Response to referees' comments (hess-2019-281)

The manuscript "Widespread decline in terrestrial water storage and its link to teleconnections across Asia and Eastern Europe" by Liu et al., submitted to HESS, analyses the terrestrial water storage (tws) for regions with declining tws based primarily on GRACE, hydrological modelling data and literature values, links it to a huge number of teleconnections and separate tws both in seasonality and compartments and link it as well to teleconnections. While the manuscript started promising (and the idea of linking TWS dynamics to teleconnections is interesting), it has several drawbacks both structural and content-wise. Simultaneously, I have the impression that the manuscript was not prepared carefully and properly reviewed by the co-authors before the submission. Otherwise I could not understand the number of the major and minor very obvious problems that made it hard to focus on the content of the manuscript. In sum, I have doubts, if a major revision could lead to an acceptable improvement for the high journal standard and therefore recommend to reject the manuscript but I of course leave it up to the editor if the chance for improv

40 **Figure 2: Methodology flow diagram of data processing in this study.**

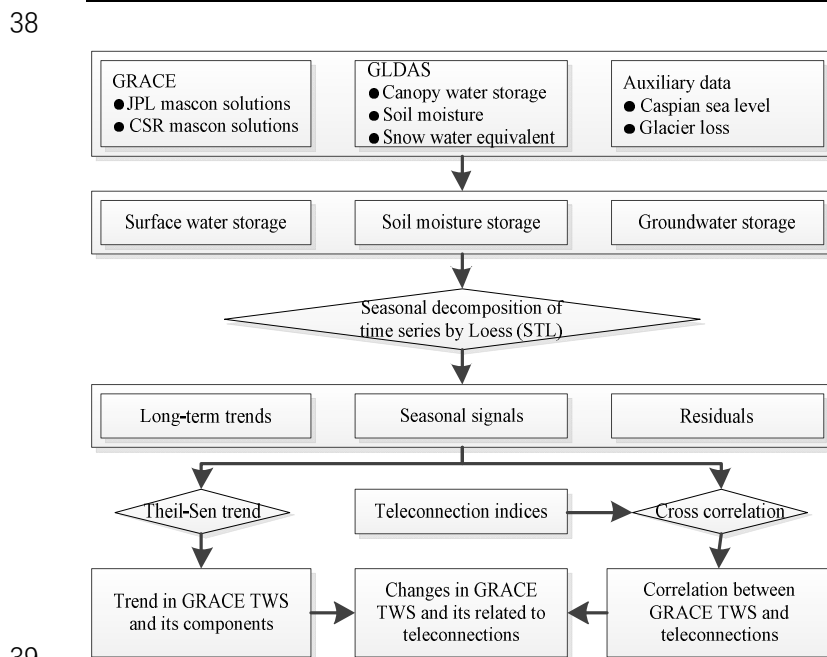
(2) The method section does not provide the details that are needed to understand the results. Should the reader know every single teleconnection? What are the methodological details of assessing water storage changes for lakes (e.g. are reservoirs included?), how are glaciers included (a reference to literature does not allow a reader to really get a clue how specifically the data has been included in this study)? Wetland and river storage seem to be missing at all in the study – at least those are not indicated in the definition or in data sets used.

32 **Response: Thank you for your comments. In our revised manuscript, we have tabulated the datasets used in our**
 33 **study. The lakes and glaciers that considered in our study are listed in the table (Table 1). The rivers and reservoirs**
 34 **indeed not included in our study, we have discussed the associated uncertainties in discussion section. We also**
 35 **made a methodology flow diagram of data processing in our revised manuscript (Figure 2, marked by the figure**
 36 **number in the revised manuscript, hereafter).**

50
51 **Figure 3: Spatiotemporal changes in TWS as obtained from GRACE (a) and precipitation as obtained from CRU (b)**
52 **across the Asian and Eastern European regions during 2002-2017. The trend is obtained from the removed seasonal**
53 **cycle time series.**

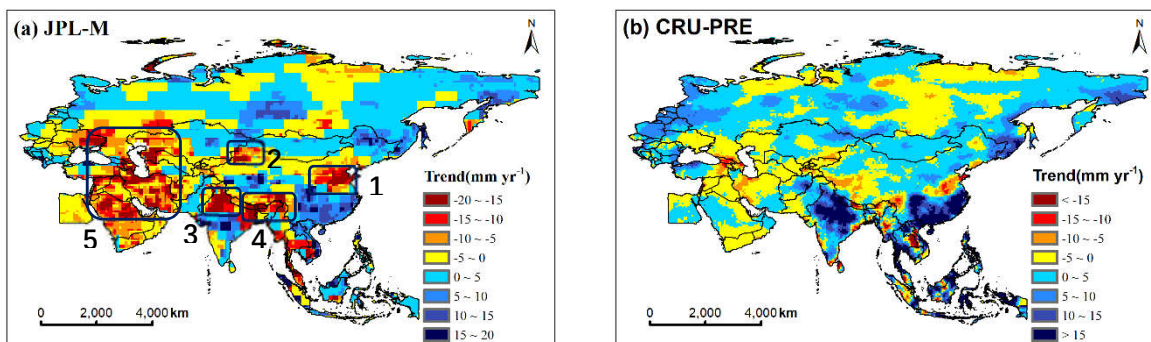
41 (3) The results section contains a too short and selective description of the results, often followed by an
42 interpretation. Should it be up to the reader what the result of the study or the interpretation is? There are
43 questionable interpretation included, for example that the (very small) changes in precipitation is responsible for
44 the (one magnitude higher) change in TWS, or that glacier melt leads to soil moisture increase – without citing any
45 reference.

46 **Response: Thank you for your comment. We have substantially modified the inappropriate phrasing in results**
47 **interpretation, and also added citations for each interpretation. Notably, the trend in precipitation was mistake**
48 **in our former version of manuscript, we have recalculated and reproduced the spatiotemporal changes of**
49 **precipitation over the study area (Figure 3).**

260
261 **Figure 3: Spatiotemporal changes in TWS as obtained from GRACE (a) and precipitation as obtained from CRU (b)**
262 **across the Asian and Eastern European regions during 2002-2017. The trend is obtained from the removed seasonal cycle**
263 **time series.**

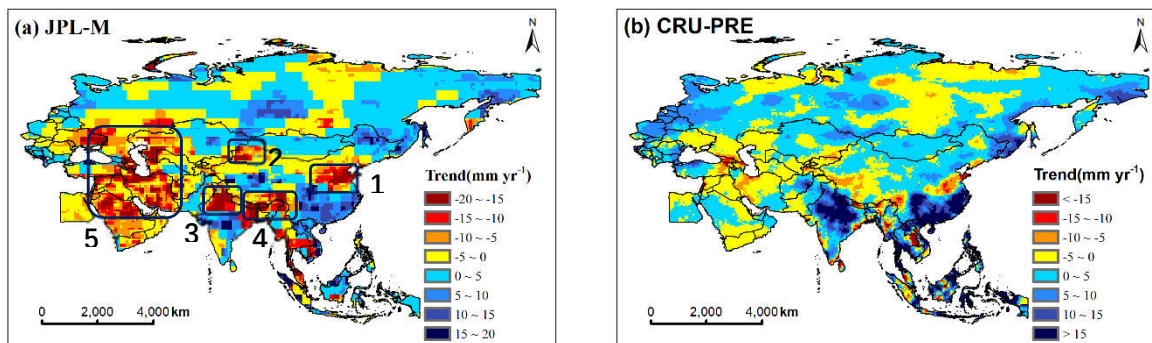
250 (31) Fig 2a and b and line 149 ff: I try to make sense out of the numbers and colours. TWS trend seems to be a
251 magnitude larger than precipitation trend. How does a precipitation change of < 1 mm/yr can be the cause for 10

252 to 20 mm tws change? Precipitation can be a cause, yes, but if the numbers are correct, then I cannot agree that this
253 is the reason and similarly I not agree that there where the pattern looks differently, human impact is the (only)
254 reason. This needs by far more discussion and thorough analysis. From Table S1 some differences are visible for
255 the two Mascon solutions. I suggest to display the two Mascon solutions in Fig 2. The regions in Table S1 could
256 get names.

257 **Response: Thank you for your comment. We feel sorry for the mistake in trend analysis of precipitation in our**
258 **former version of manuscript, we have recalculated and reproduced the spatiotemporal changes of precipitation**
259 **over the study area (Figure 3).**

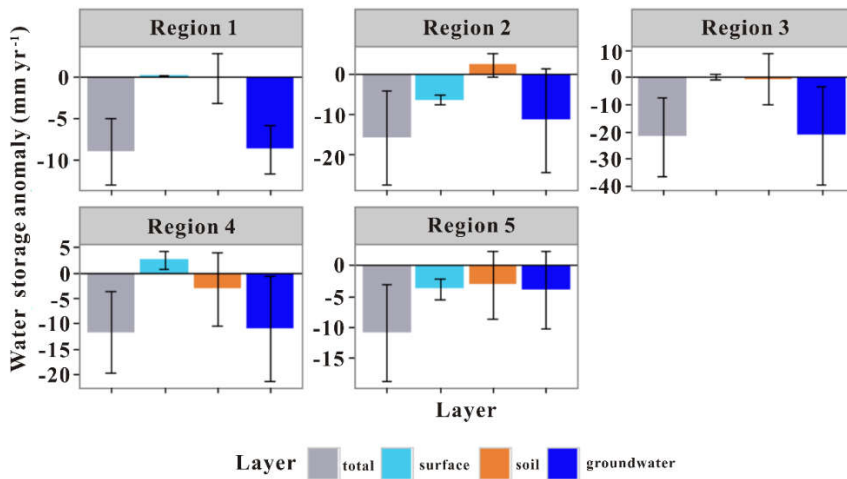
267 (33) Fig 2f: a legend is missing, and I can only see 4 lines and a mess of shaded area which does not allow any
268 meaningful assessment. Please re-arrange (e.g. splitting it up to 5 single plots with same Y-axis) and it would be
269 meaningful to use month/years for x-axis.

270 **Response: Thank you for your comment. Since this figure mainly presented the TWS trend for five hotspots,**
271 **which is similar to the figure 5 (see below). Therefore, we have deleted this figure in our revised manuscript.**

273 **Figure 5:** Contributions of different hydrological storages to TWS changes in five hotspots. Uncertainties represent
 274 the 95% confidence intervals.

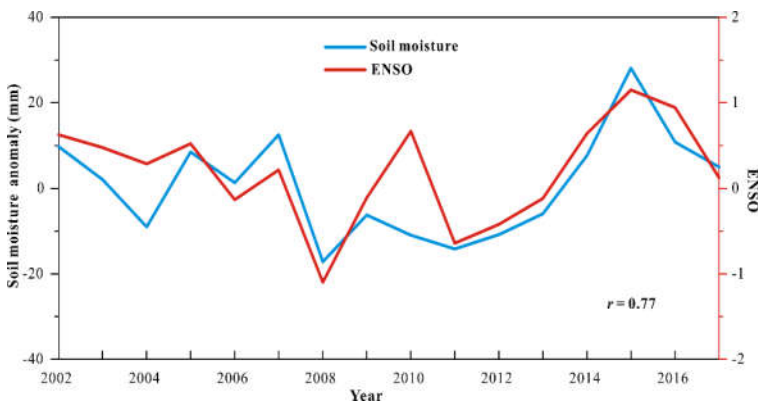
275 (34) Fig 3: Labelling of Y-Axis with “Water loss” and then negative values – does it imply a water gain? Please
 276 name it more meaningful.

277 **Response:** Thank you for your comment. We have rectified this mistake, and replaced “water loss” of “water
 278 storage anomaly” in our revised manuscript.

Figure S1. Comparison between GRACE observed terrestrial water storage and GLDAS simulated terrestrial water storage by summing canopy water, four layers soil moisture and snow equivalent water over the Asia and Eastern Europe region during 2003~2016.

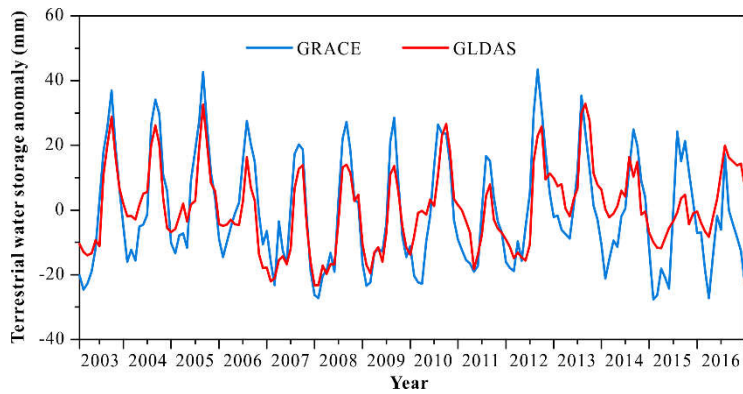
285 (36) Fig S1: unit for Y-Axis is missing. I suggest to use month/years instead of month numbers. Why does the time
 286 series ends ~at month 165 whereas the other figures are ending at month ~177/181?

287 **Response:** Thank you for your comment. The total study period is during April 2002~June 2017, but we use full
 288 years for comparison between 2003 and 2016, therefore the time series is during 1~168. We have reproduced the
 289 figure by using month/year (Figure S1).

Figure S4. Changes in Caspian Sea Level during 2002-2017.

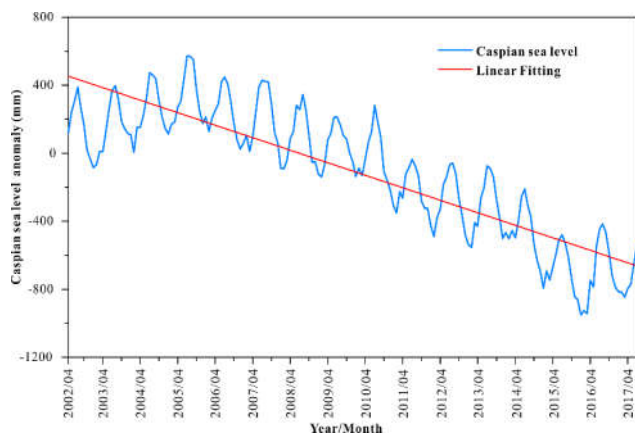
(37) Fig S3: what is shown at X- and Y-Axis?

Response: Thank you for your comment. We have reproduced this figure in our revised manuscript (Figure S4).

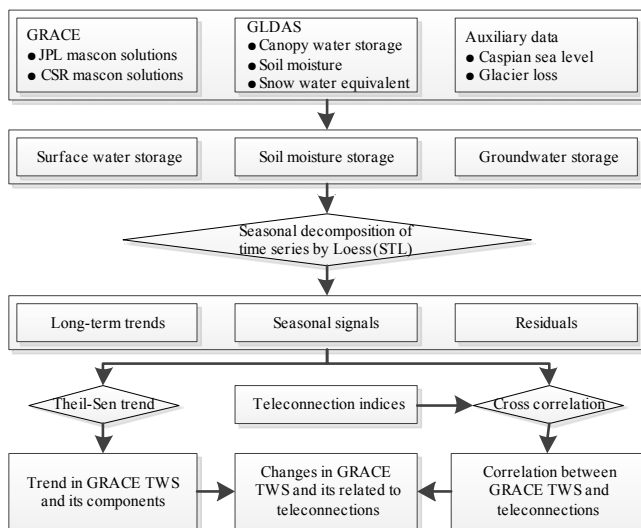
247 (30) Fig 1 and lines ~75: sources are missing for definition of humidity and for area equipped for irrigation

248 **Response: Thank you for your comment. We have supplemented the sources for definition of humidity and for**
249 **area equipped for irrigation in figure caption.**

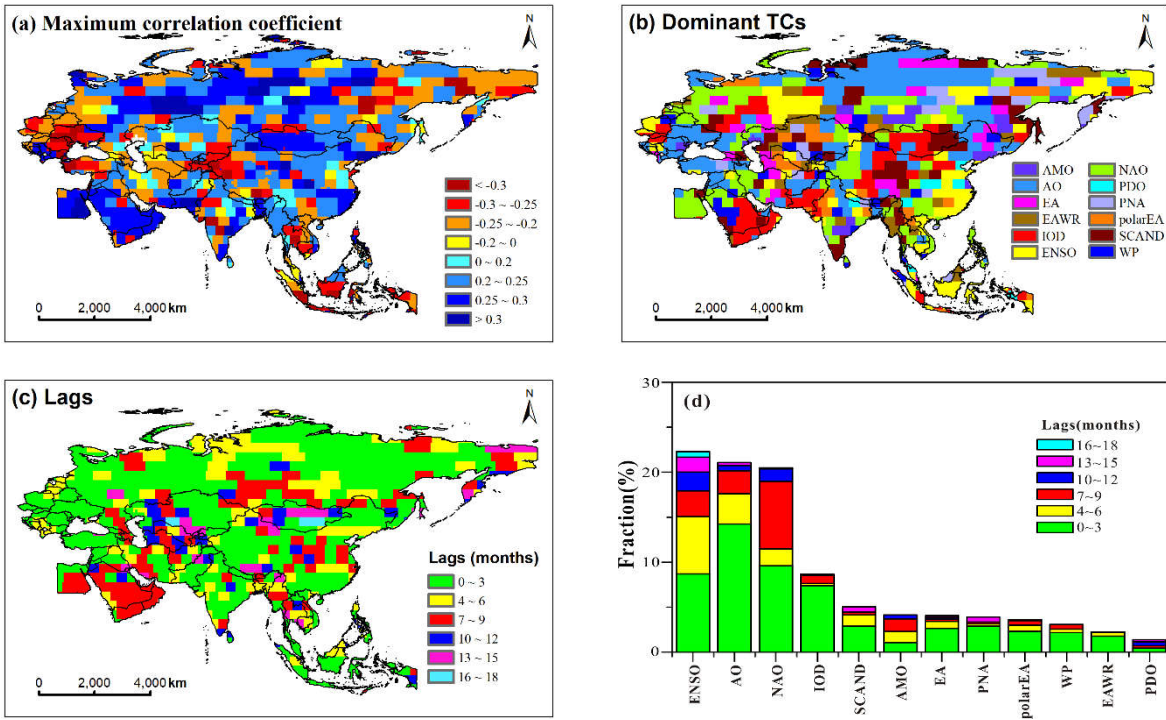
(25) Section 3.2: I have hard times interpreting and justifying the results. First, maximum correlations are relatively low (Fig. S5) and I guess, only the TC with the dominant correlation is displayed in Fig 2. However, how to interpret plausible, if a correlation coefficient is, let’s assume 0.20 and the next TC has 0.19? The interpretation (such as time lag discussion) solely considers the maximum correlation even though it is in a large part of the study area

220 very low. A correlation coefficient of 0.2 implies that this specific TC explains 20% of the TWS signal, is this
221 correct? This needs more attention and maybe cutting out dominant TCs below a meaningful threshold.

222 **Response: Thank you for your thoughtful comment. We indeed adopt the maximum correlation coefficient as the**
223 **dominant TC. We also agree with your comment, and the situation mentioned above could occur in data**
224 **processing. However, the pixel is independent each other. For each pixel, we could extract the maximum**
225 **correlation coefficient between TWS and TCs, but we could not obtain the area proportion of each dominant TC**
226 **during extraction process. Therefore, we adopted maximum correlations to interpretation, and we also discussed**
227 **this uncertainty in discussion section of our revised manuscript.**

Figure 6: The residual time series of spring soil moisture and associated ENSO in region 3 during 2002-2017.

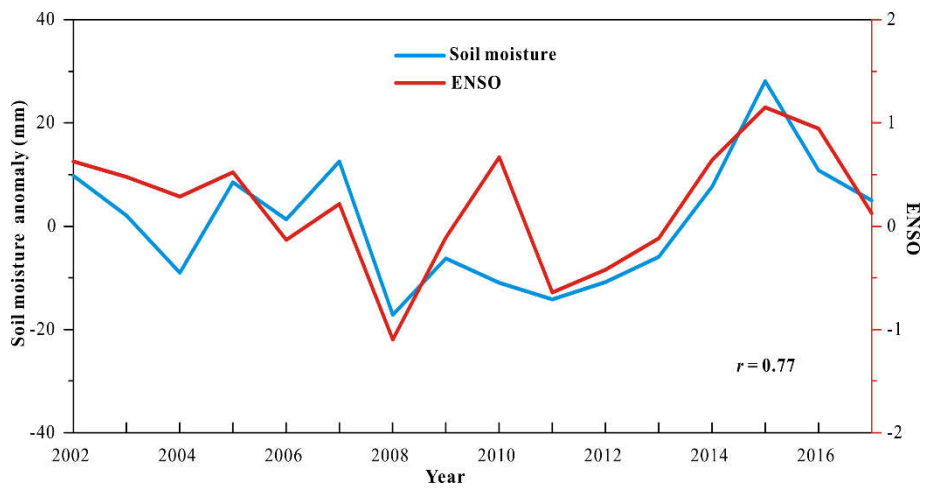
279 (35) Fig 4: what can be seen at both axis? It seems that the months are not consecutive (If I interpret it correctly as
 280 spring season), then drawing a solid line through it is misleading.

281 **Response:** Thank you for your useful comment. We have aggregated monthly data to yearly data in our revised
 282 manuscript (Figure 6).
